STAFF RECOMMENDATION 1909 Russell Street April 19, 2017

Application: New construction—detached accessory dwelling unit; Setback determination

District: Lockeland Springs-East End Neighborhood Conservation Zoning Overlay

Description of Project: Application is to construct a detached accessory dwelling unit (DADU) at the rear of the lot. The structure requires a rear setback determination from twenty feet (20') to ten feet (10').

Figure 1. 1909 Russell Street.

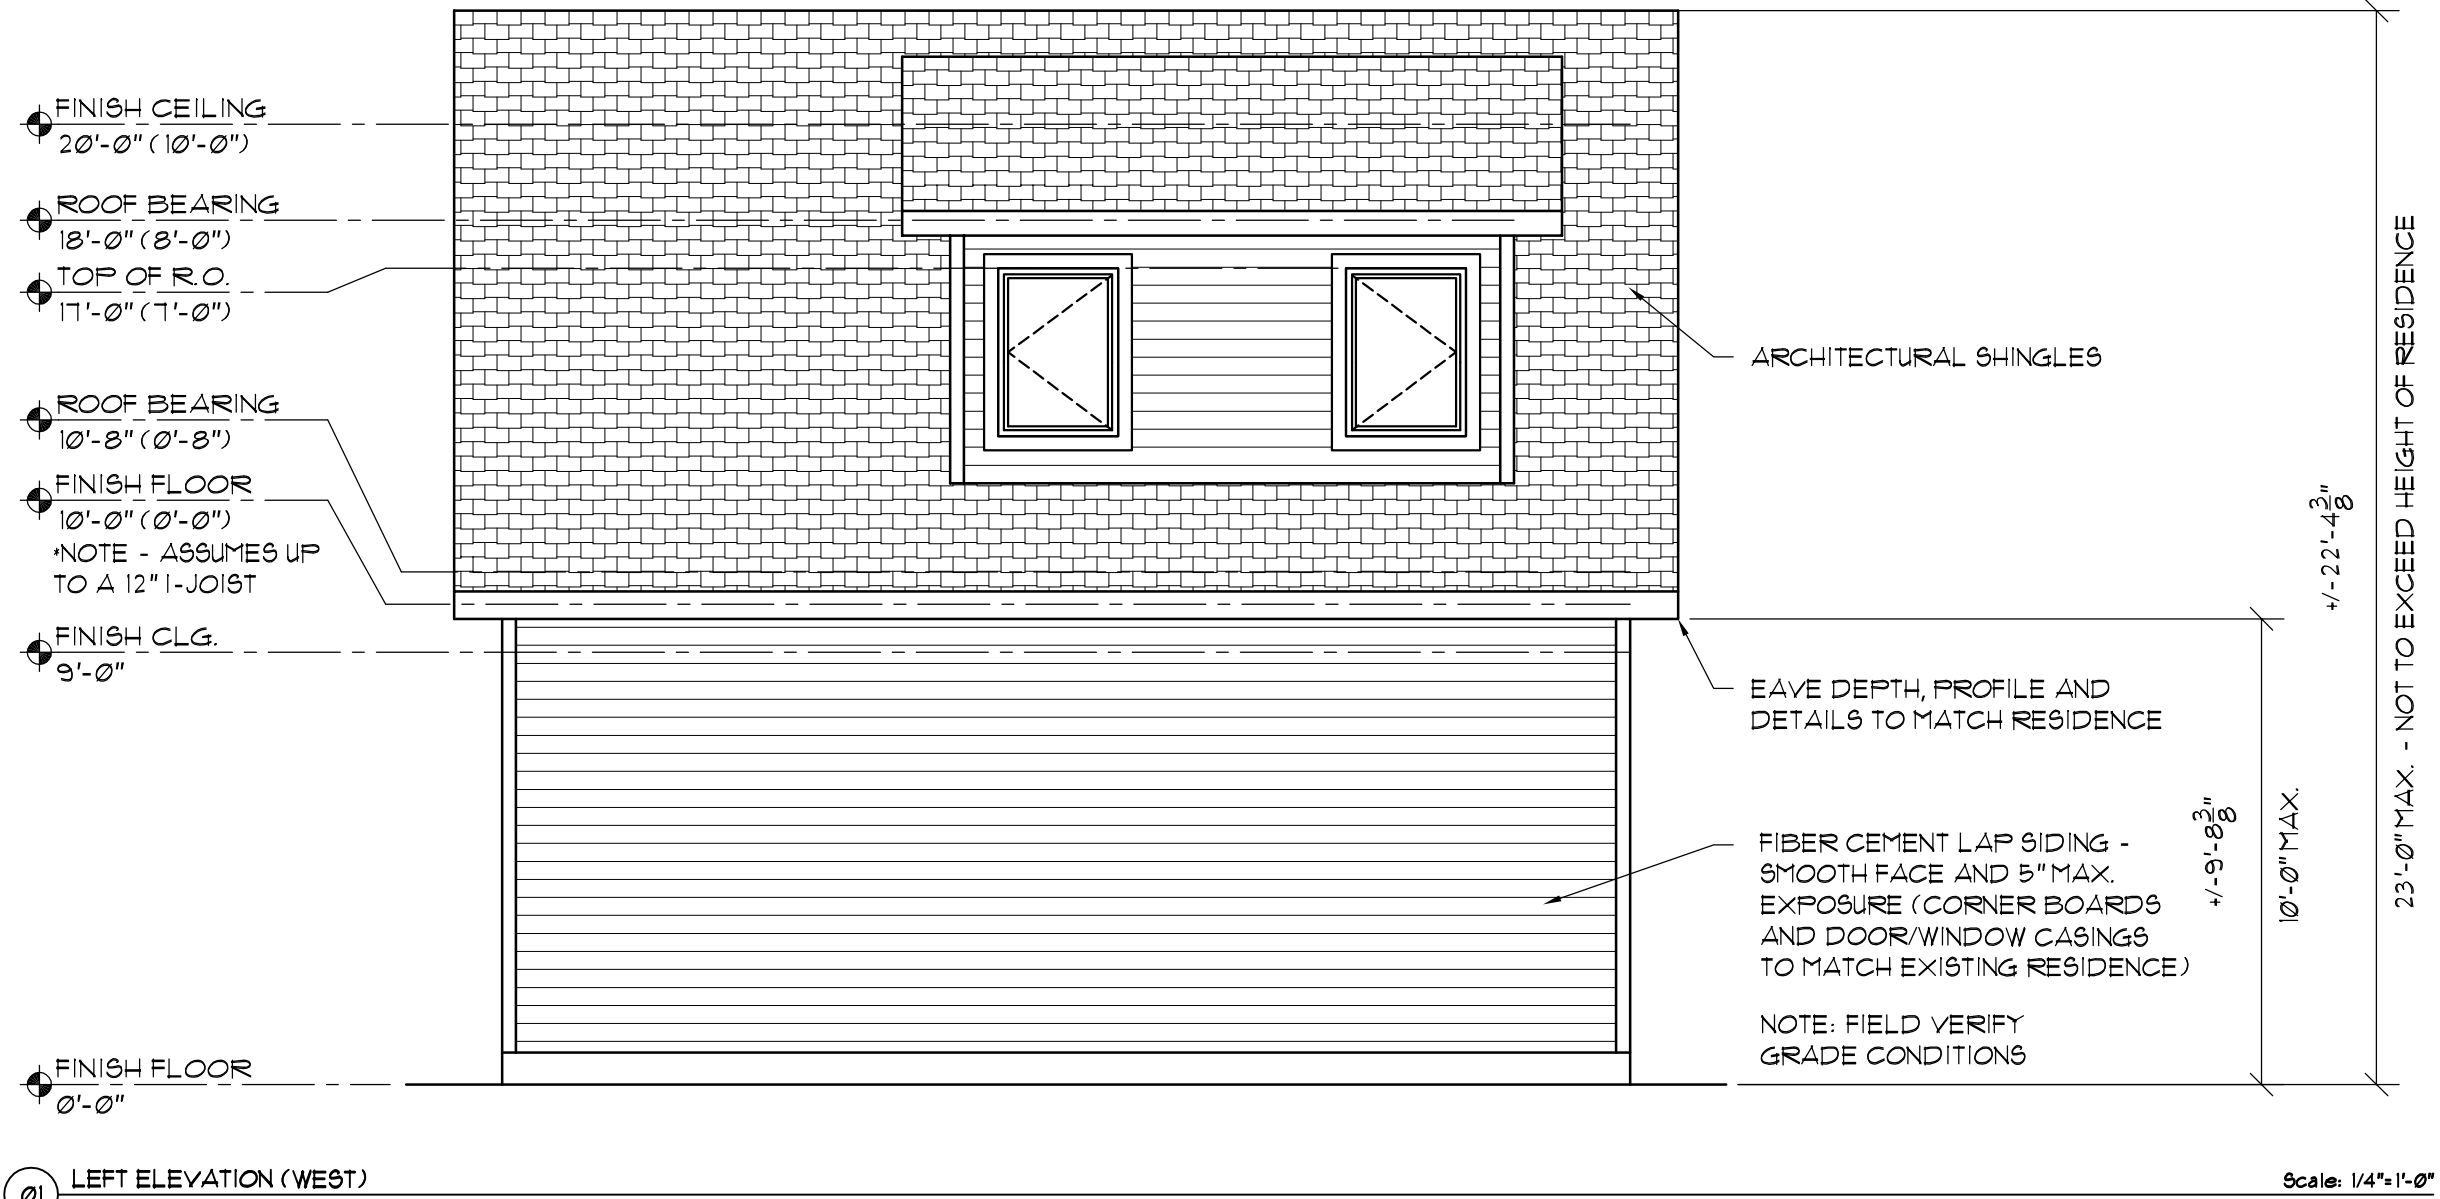
Background: 1909 Russell Street is a c. 1920 folk Victorian house that contributes to the historic character of the Lockeland Springs-East End Neighborhood Conservation Zoning Overlay (Figure 1). In February 2017, MHZC staff issued an administrative permit for a rear addition to the house.
